## SUBDIVISION REVIEW SHEET

**CASE NO.:** C8-2022-0180.0A

**SUBDIVISION NAME:** Resubdivision of a Portion of Lots 8, 9 and 10, John M. Edwards Subd.

**CITY OF AUSTIN –DEVELOPMENT SERVICES DEPARTMENT  
SUBDIVISION APPLICATION – MASTER COMMENT REPORT**

VICINITY MAP  
NOT TO SCALE

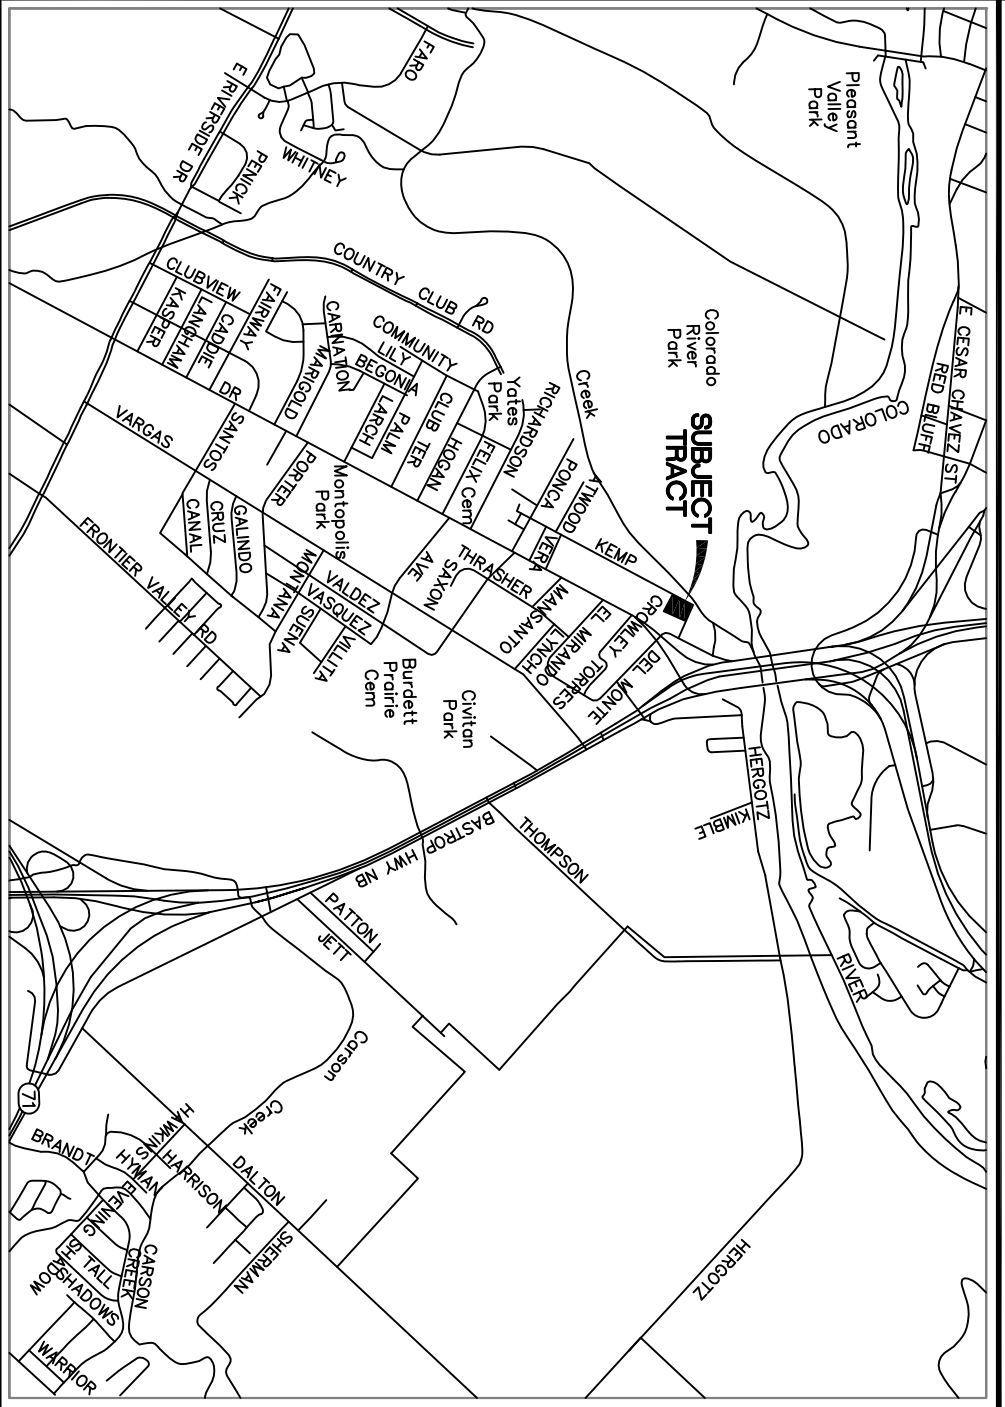
AD2: Please remove all street labels in the vicinity map **EXCEPT** the following:

1. Please update label for **KEMP ST** the street type ST must be included
2. Please change the label for **BASTROP HWY SB** so that **BASTROP HWY SB** appears above the label US 183. US 183 should be enclosed within parenthesis and not be bold.

3. Please update label for **DEL MONTE RD** the street type RD must be included
4. Please update label for **CRUMLEY LN** the street type LN must be included. Name is labeled as CROWLEY
5. Please include the label for **MONTOPOLIS DR**
6. **E RIVERSIDE DR**

NOTE: CRUMLEY LN is incorrectly labeled as CROWLEY on all sheets.

Exhibit B

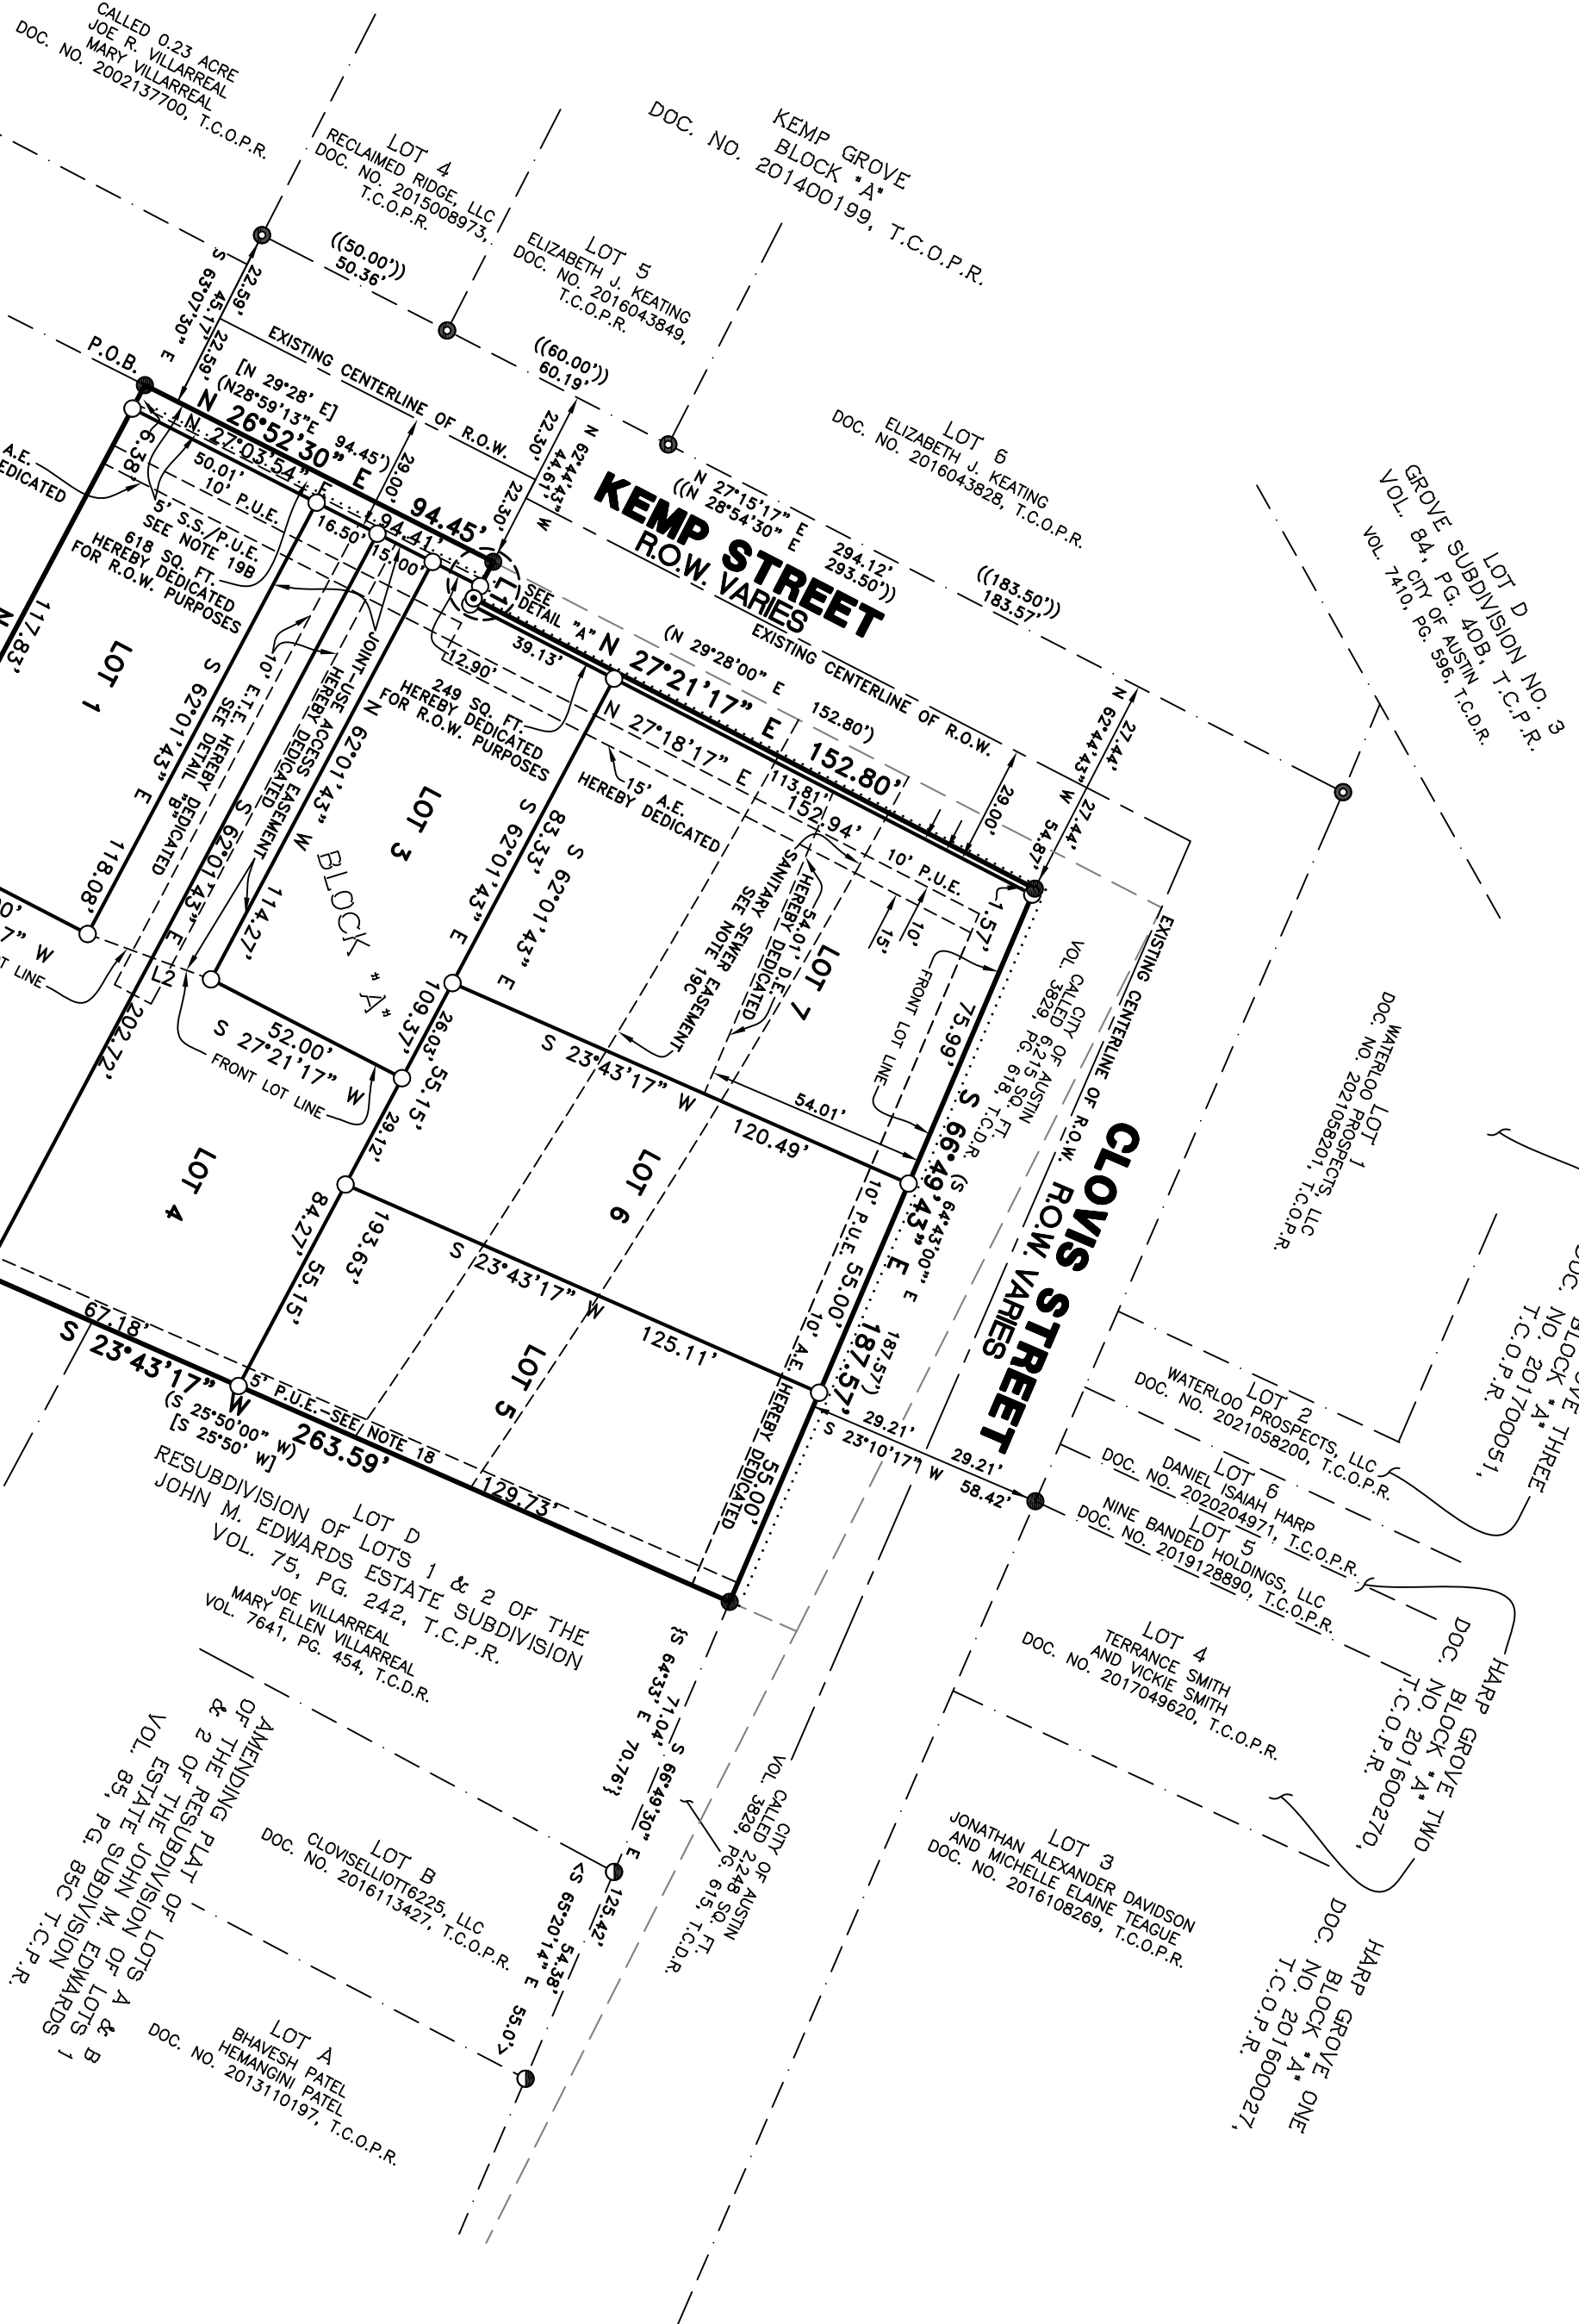
**Please label 15' electric easement on Kemp St and 10' electric easement on Clovis St as 'aerial electric distribution, electric telecommunications, and electric fiber' easements.**
